RE: **The Nest SWFL (formerly known as Eagle's Nest) - DCI2022-00004
Planned Development Application RPD/CPD - Submittal 4
(ABB PN: 20-0017)**

This letter is in response to the County's comments dated September 6, 2022, to the Planned Development application for the above-referenced project. Responses to each comment are provided below in ***bold italics***.

The Nest SWFL DCI2022-00004

5. Revised Surface Water Quality Monitoring Plan & Exhibit

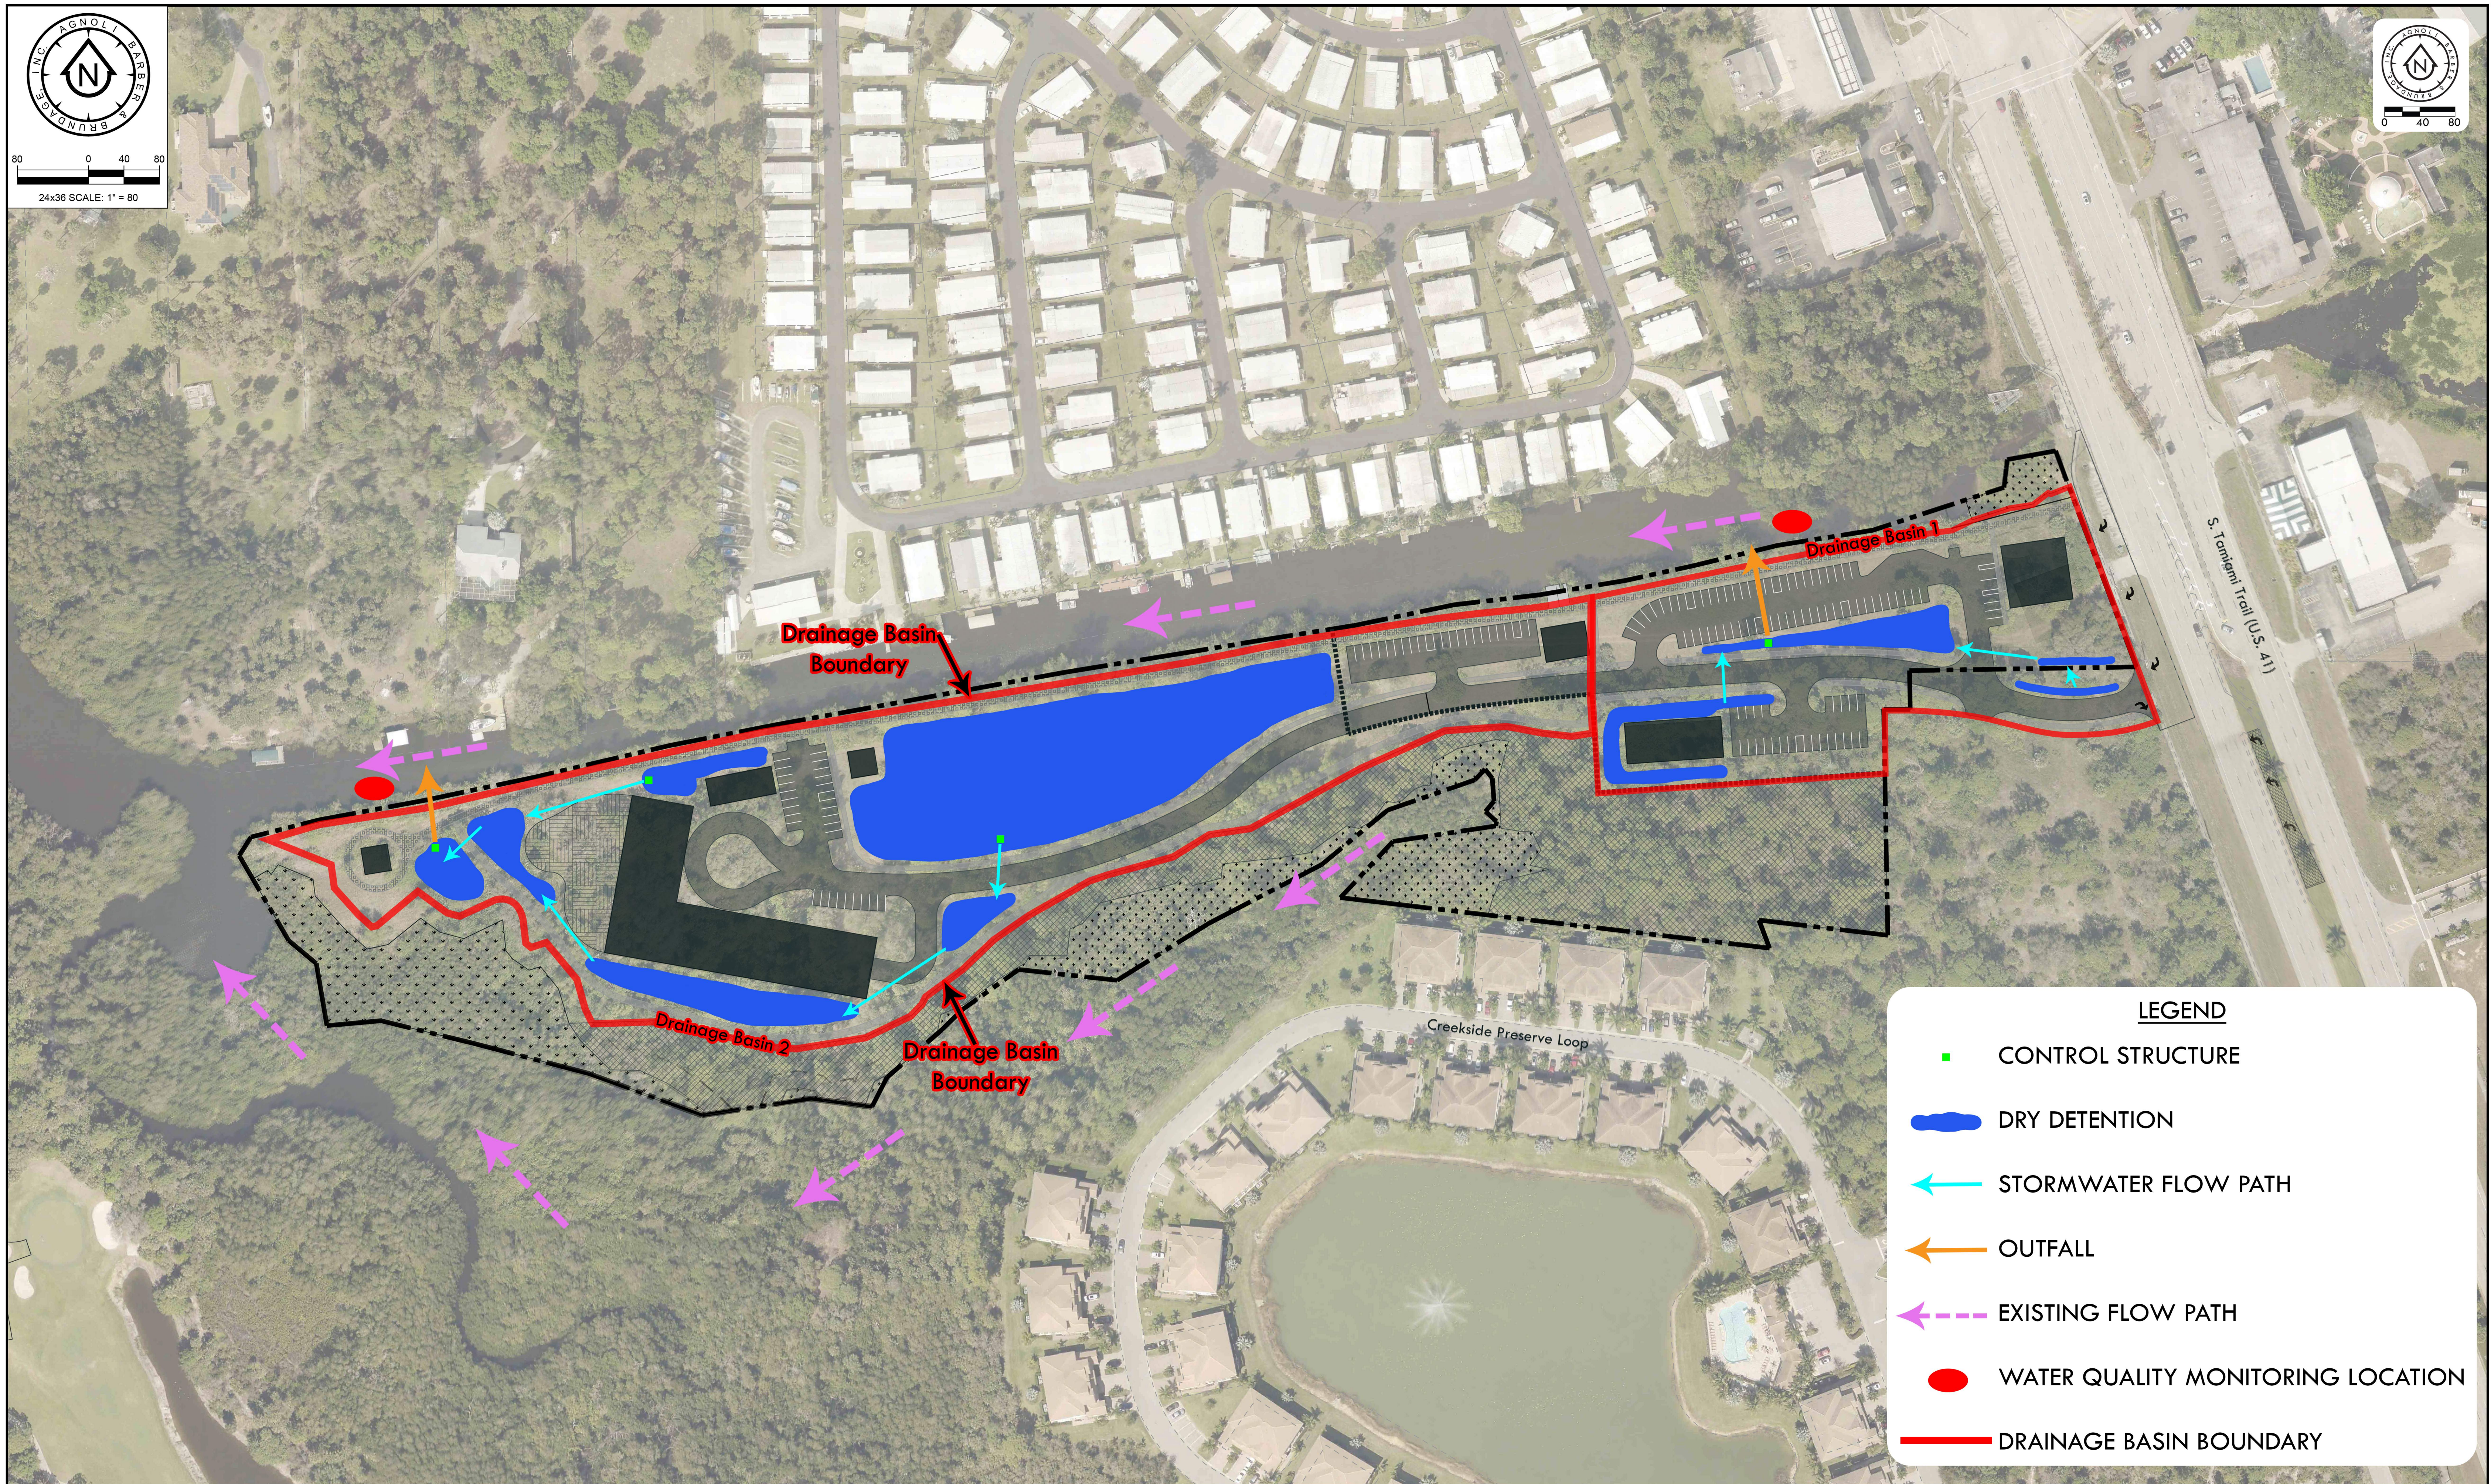
Please revise the proposed water quality monitoring plan to include a sampling location map at each proposed outfall.

Response: Please see attached Surface Water Quality Monitoring Program Exhibit.

7. Revised Boundary Survey and Legal Description

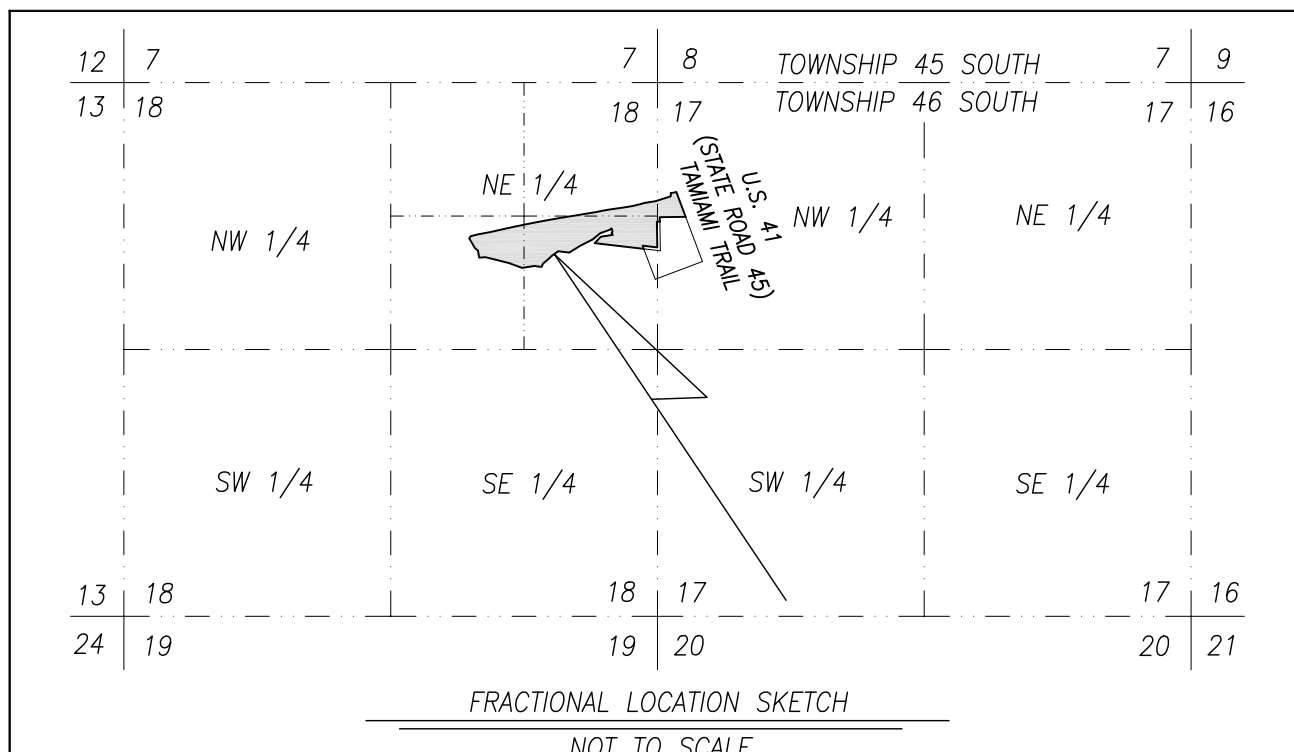
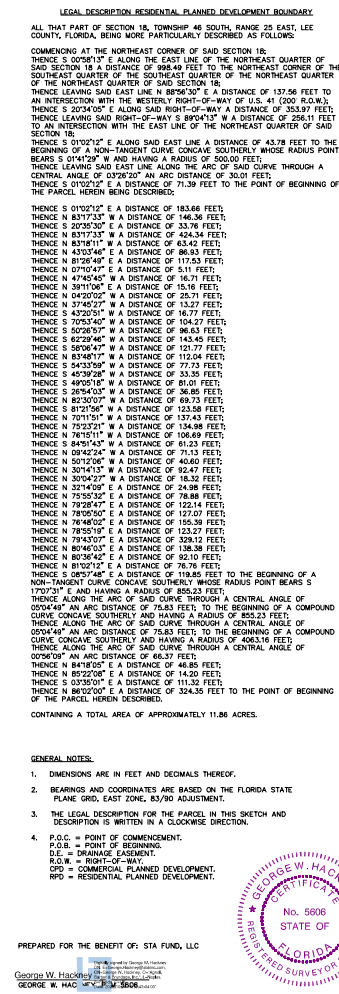
Please provide a legal description and sketch in accordance with the requirements of Lee County LDC §34-202(a)(5). If the subject property is one contiguous parcel, the legal description must specifically describe the entire continuous perimeter boundary of the property subject to the zoning action with accurate bearings and distances for every line.

Please provide a boundary survey in accordance with the requirements of Lee County LDC §34-202(a)(6). The survey must be based upon the title certification submitted in accord with section 34-201(a)(7).

Response: Please find attached the revised boundary survey of the overall project as well as the

revised sketch and descriptions of the RPD and CPD areas of the project.

Response: Please find attached the revised Title certificate and boundary survey of the overall project as well as the sketch and descriptions of the RPD and CPD areas of the project.

8. Revised Sketch and Description RPD

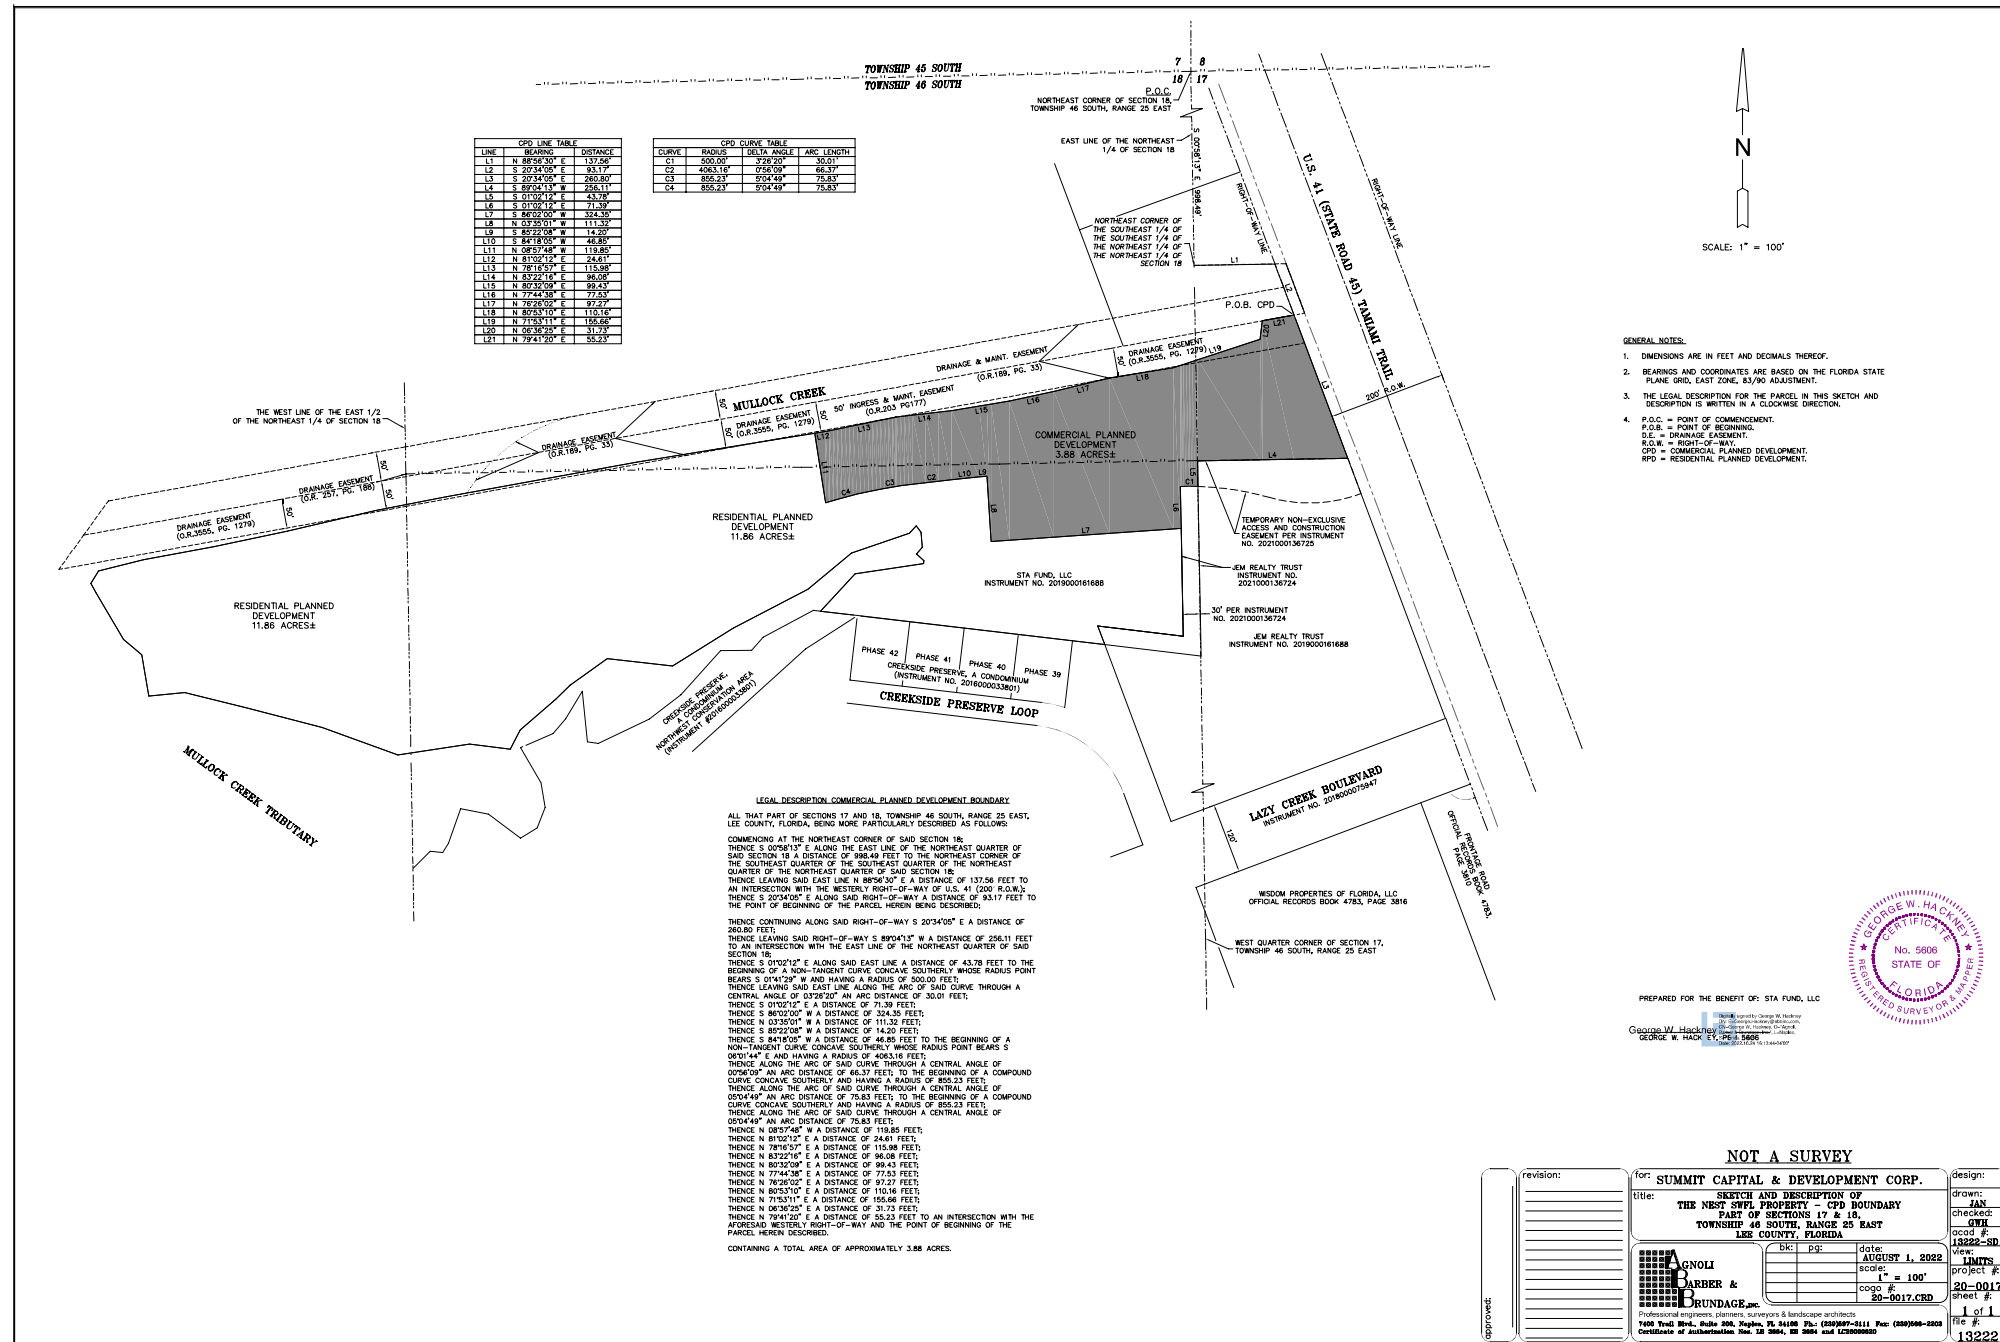
For a CPD/RPD zoning The Code (LDC Section 34-373(a)3 requires separate legal descriptions and sketches for RPD and CPD sections, as well as one overall legal description and sketch for the entire development. Please provide legal description and sketch for RPD and CPD with your legal description and sketch for the entire site.

Response: Please find attached the boundary survey of the overall project as well as the sketch and descriptions of the RPD and CPD areas of the project.
